# Santolina Level 'A' Master Plan

Transportation
System
Comments

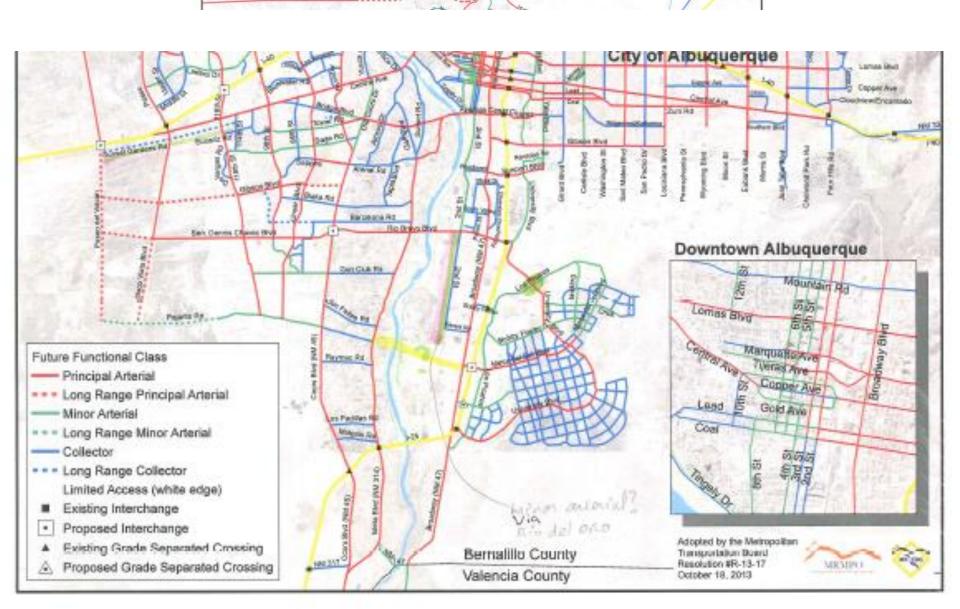
- Properties along frontage road, some parcels are part of Santolina and some owned by others, should be accessed via a roadway network located to the south.
- Language should be added to the Plan to utilize the existing 60 foot easements for connection to the south roadway network to reduce the number of driveways along the frontage road and new southerly arterial.

### **Access Management**

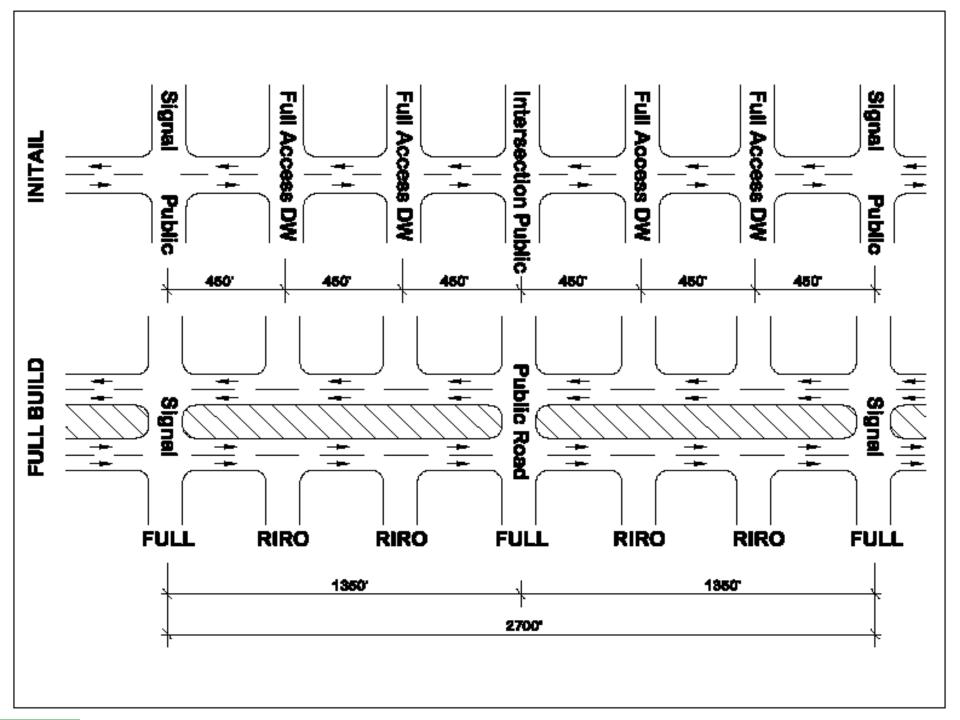
- The developer has agreed to include an Access Management Plan similar to the NMDOT's criteria to maintain and assure adequate access spacing along the major roadways within Santolina.
- Initial 2 lane roadways, when widened to 4/6 lane facilities, some businesses will lose their full access. Include language addressing this in access management section of plan.

## **Rights-of-Way**

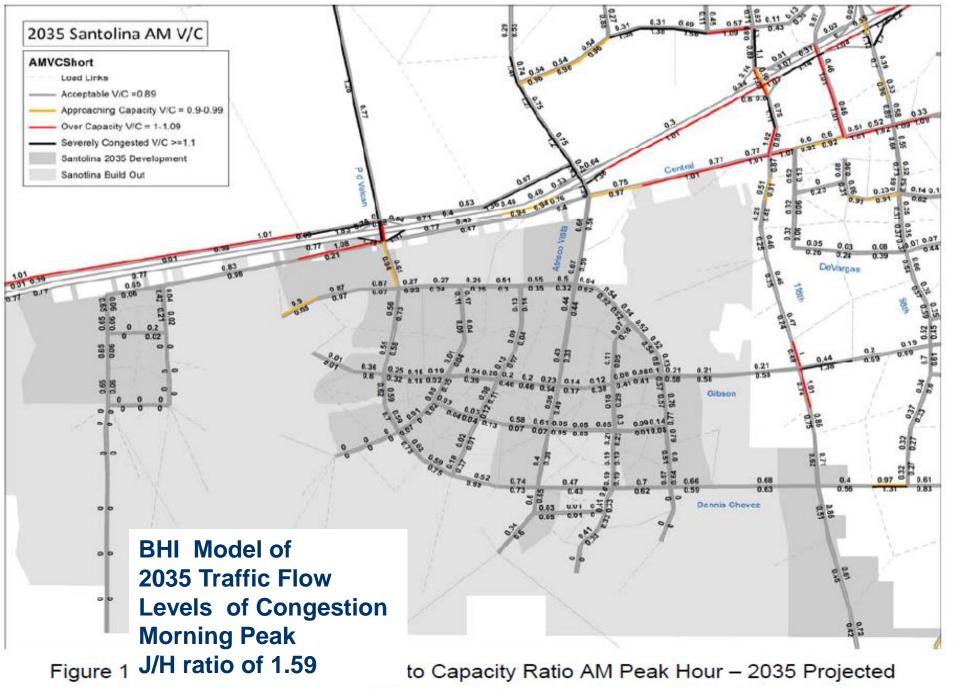
- Complete Streets, Figure 4, page 7
  - Principal Arterial w/ Transit 186' ROW
  - Principal Arterial 158' ROW
  - Minor Arterial 136' ROW
  - Collectors Level B plans
  - Grade Separated Interchange or areas near escarpment may need more ROW
- ROW dedication at Level C: subdivision, site development plan
